Docket Number 50-346
License Number NPF-3
Serial Number 1691
Attachment 3
Page 1

TOLEDO EDISON COMPANY

DAVIS-BESSE UNIT 1

CORE OPERATING LIMITS REPORT

Figure 3.1-5c APSR Position Limits, 0 to 325± 10 EFPD,
Three RC Pumps -- Davis-Besse 1, Cycle 6

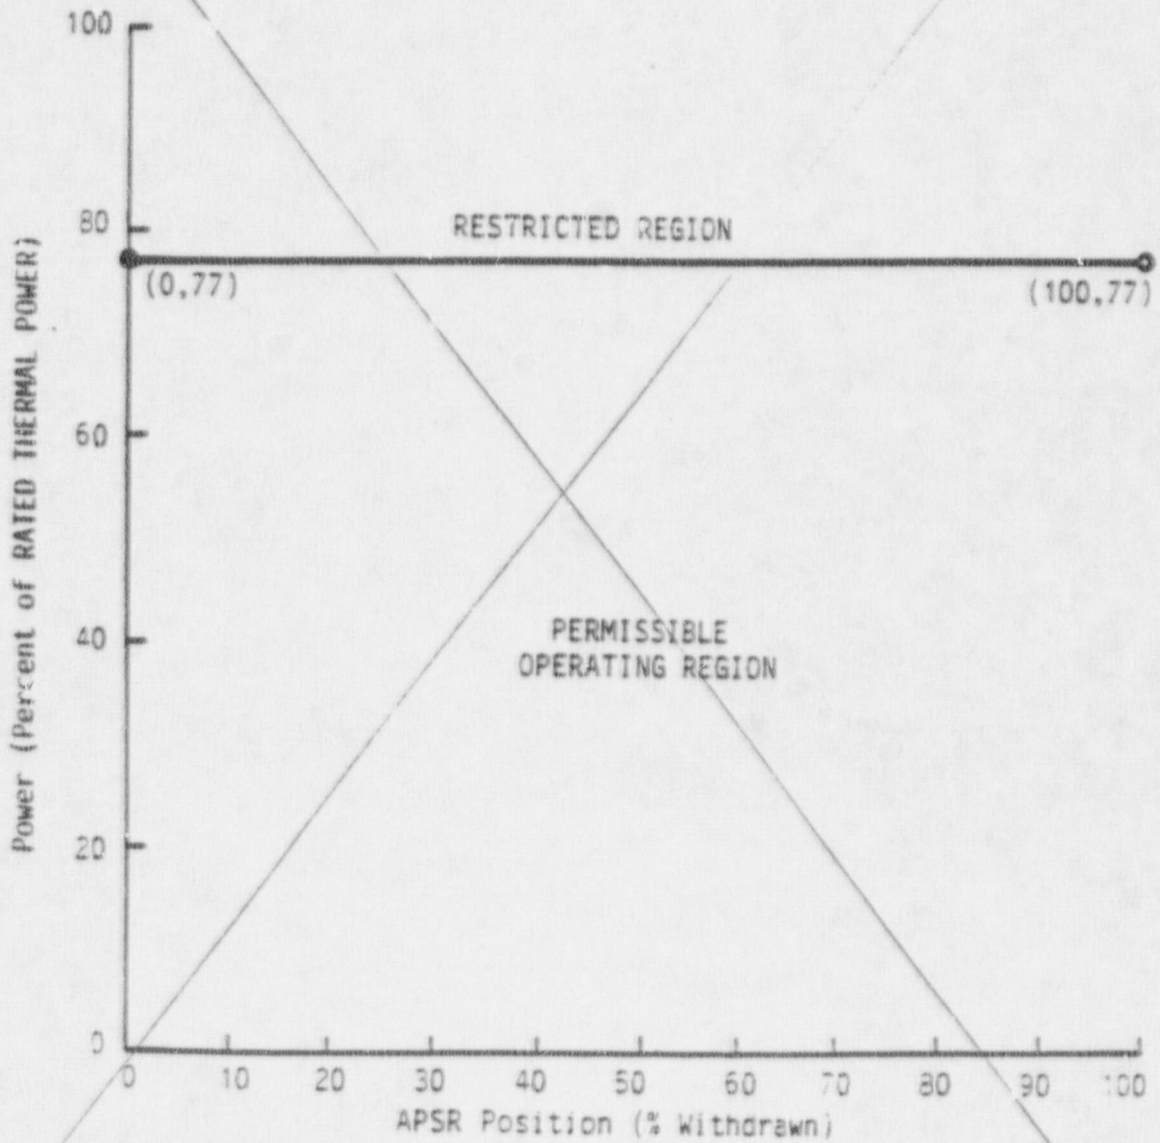
3.1.3.9 The axial power shaping rod group shall be limited in physical insertion as shown on Figures 3.1-5a, 5b, and 5c within the acceptable operating limits for axial power shaping rod position specified in the CORE OPERATING LIMITS REPORT

DELETED

Figure 3.2-1 AXIAL POWER IMBALANCE Limits,
Four RC Pumps -- Davis-Besse 1,
Cycle 6

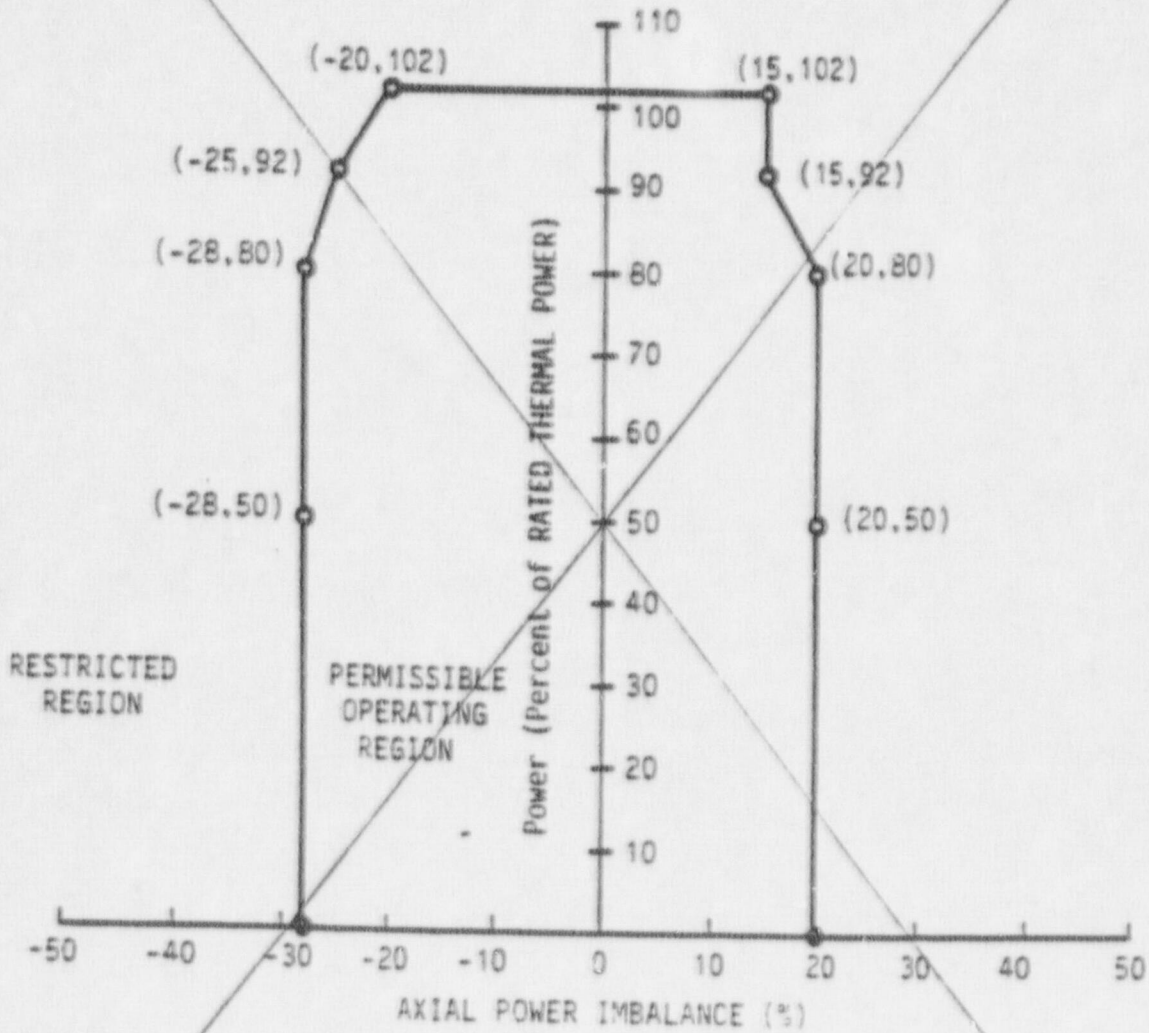
3.2.1 AXIAL POWER IMBALANCE shall be maintained within the limits shown on Figures 3.2-1 and 3.2-2, acceptable AXIAL POWER IMBALANCE operating limits provided in the CORE OPERATING LIMITS REPORT.

DELETED

Figure 3.2-2 AXIAL POWER IMBALANCE Limits,
Three RC Pumps -- Davis-Besse 1,
Cycle 6

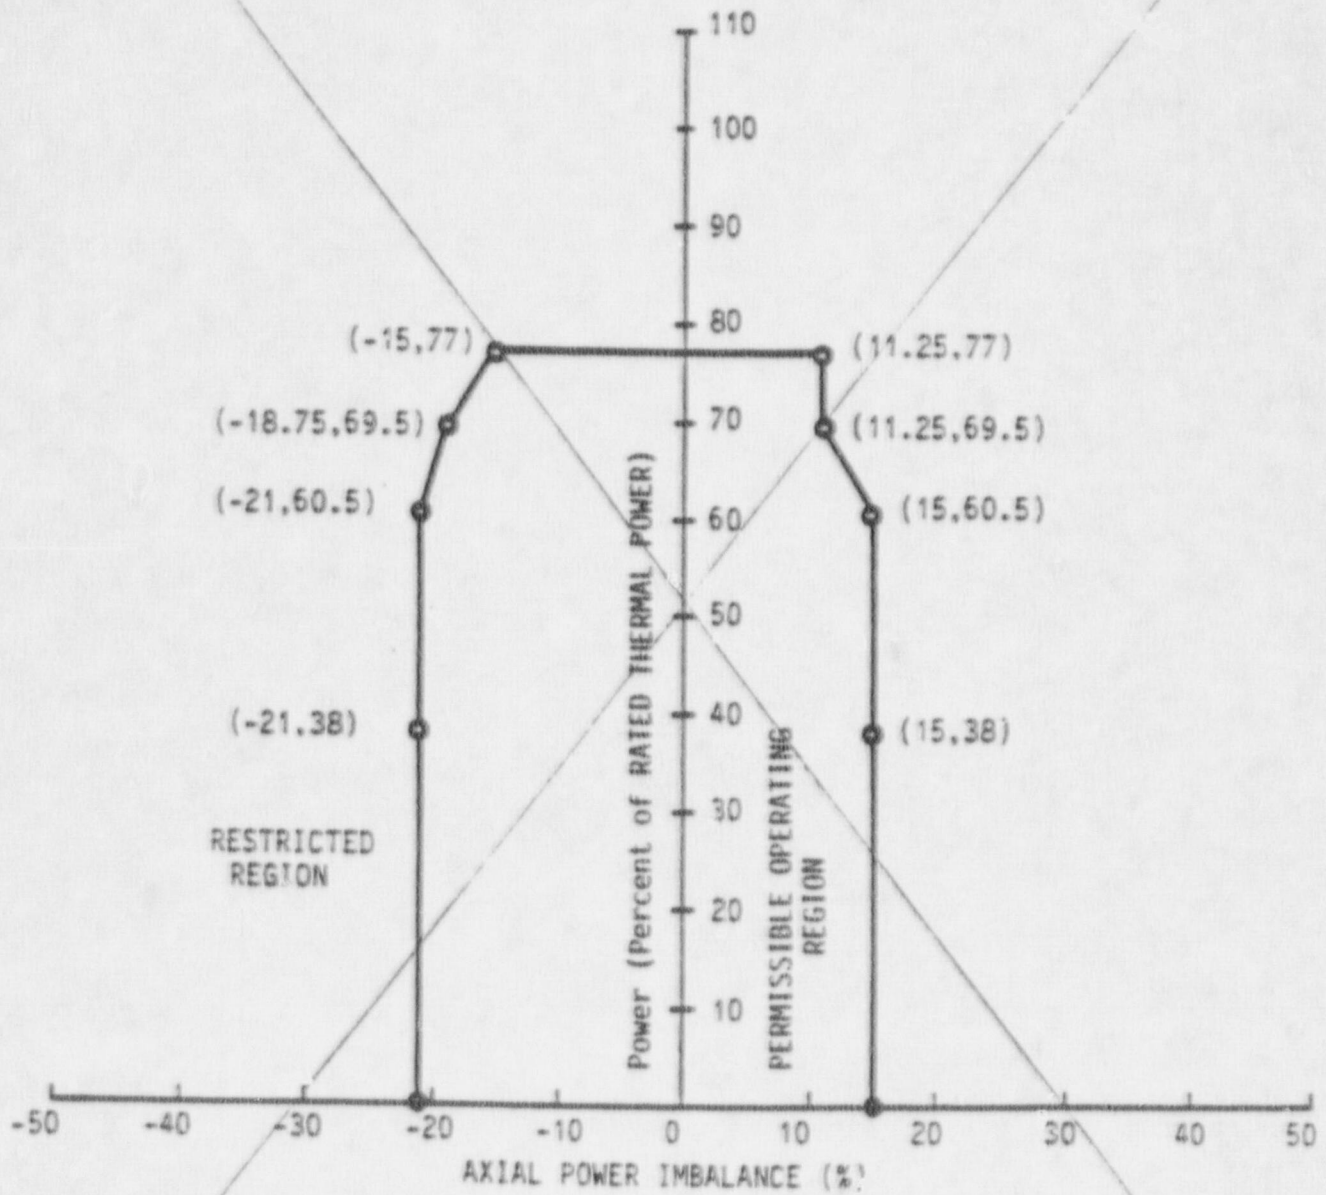
DELETED
